**RE: State Significant Development Application SSD-70316465 1953-2109
Elizabeth Drive, Badgerys Creek (Burrah Park)**

Appendix 1 – General comments on stormwater design

Appendix 1A: Technical Review from Sydney Water’s consultant, Civile

Figure 4 Approximate 40m offset from Cosgroves Creek, showing proposed road

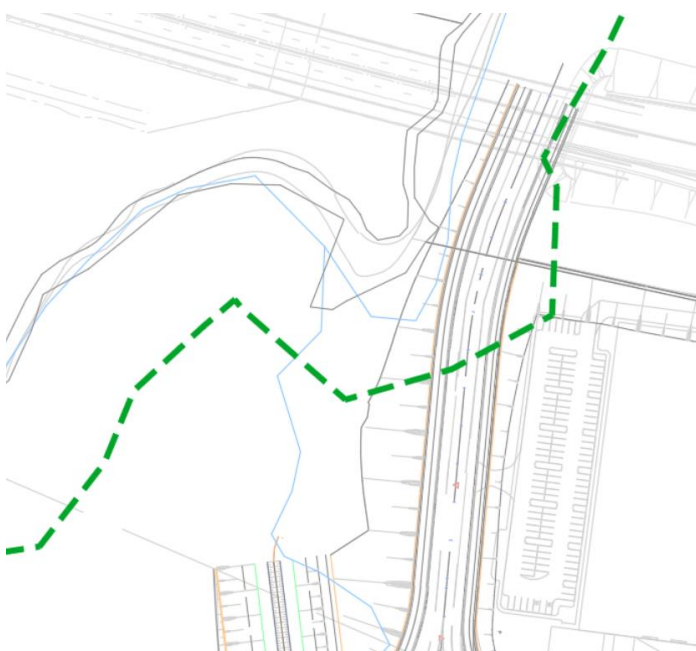
The development also proposes a road link to land on the northern side of the M12. As shown in **Figure 4** this road encroaches into the VRZ of Cosgroves Creek, a fourth order watercourse.

Recommendation: That the natural waterway be retained consistent with the DCP. The alignment of the linking road be further reviewed to be consistent with the waterfront land guidelines and located outside of the 40m riparian offset.

Figure 5 Stormwater treatment systems currently proposed, with aerial image

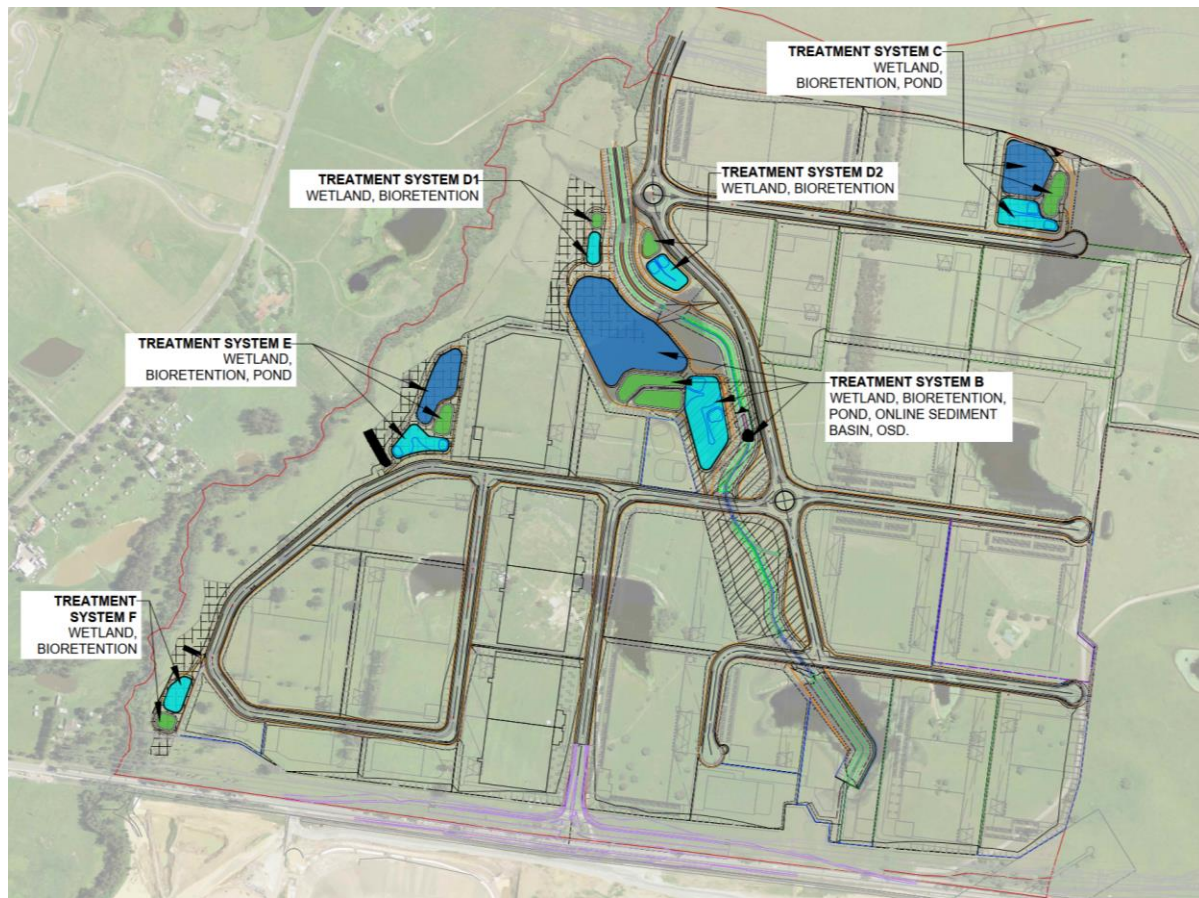
However the trunk drainage corridor in the proposed Burrah Park arrangement appears to end around 140m north of Elizabeth Drive (refer **Figure 5**). The trunk drainage corridor should extend to Elizabeth Drive, and be coordinated with the stormwater basins being delivered as part of the Elizabeth Drive upgrade project.

The basins and trunk drainage corridor currently proposed for Burrah Park are shown in Figure 5.

Each of the five stormwater treatment system needs to have all four components of the treatment train, sediment basin, wetland, bioretention and storage pond. The developer's engineer may further review whether any of the treatment systems could be further consolidated, for example, with treated stormwater from two treatment systems flowing into a single combined storage pond.

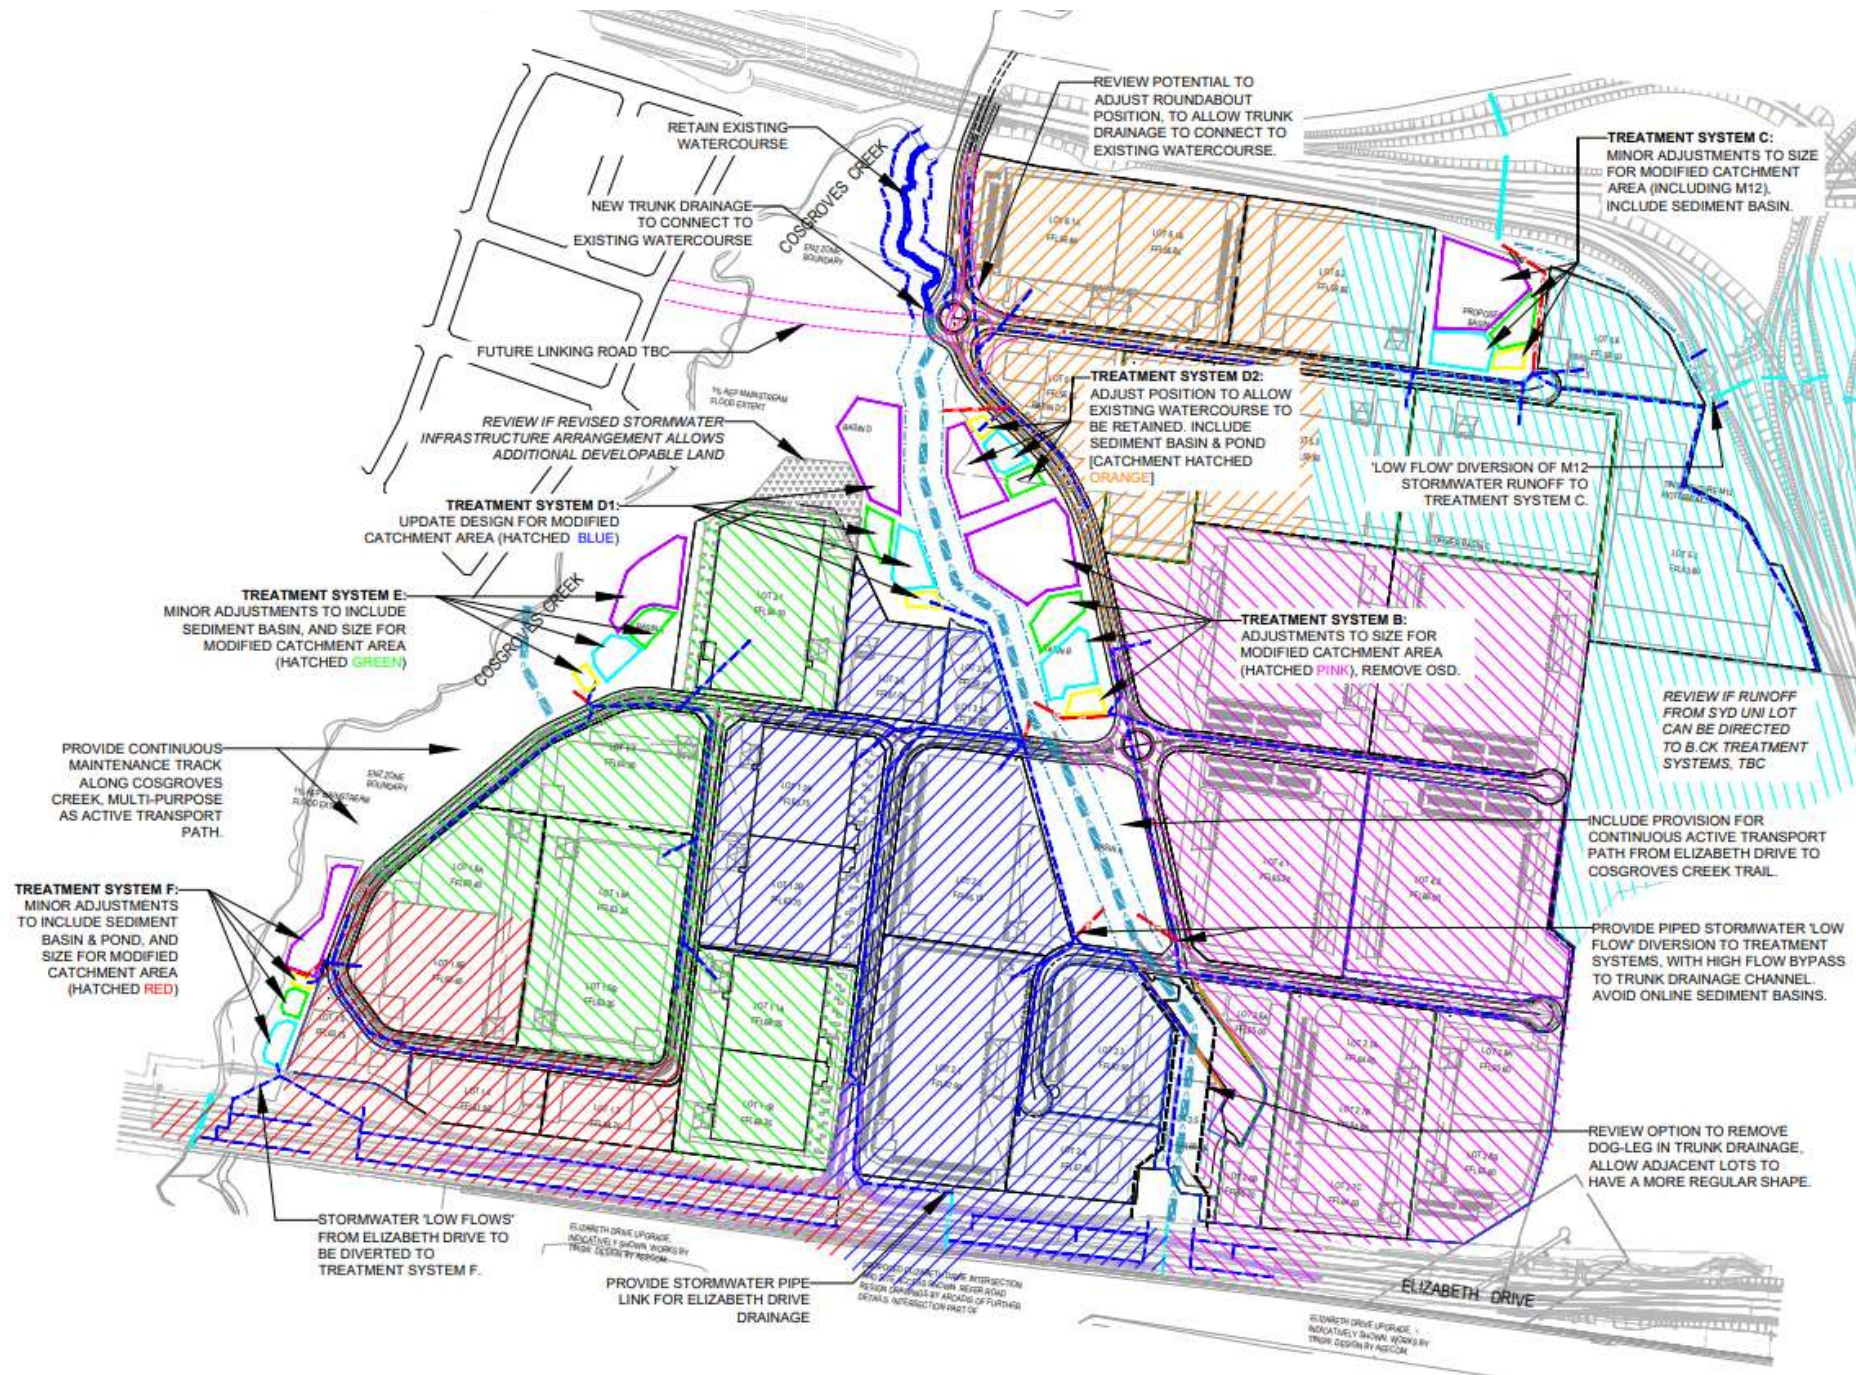
A summary of recommendations for the stormwater treatment layout as shown in **Figure 7** is outlined as follows.

Please note the following regarding the items shown in **Figure 7**:

- Levels of pipes and treatment systems are still to be verified.
- All shapes for sediment basins, bioretention, wetlands and ponds are indicative only. Engineer may revise and adjust to optimise with site arrangement and with consideration of batter slopes etc.

Recommendation: The central second order waterway should extend up to Elizabeth Drive, and include an active transport pathway if supported by Penrith Council. We recommend that the alignment of this waterway be further considered with an opportunity to realign for better overall development outcomes (See Figure 7).

A key proposed update is for the retention of the downstream portion of the second order waterway. The trunk drainage corridor is also suggested to be aligned to suit the revised treatment systems configuration.
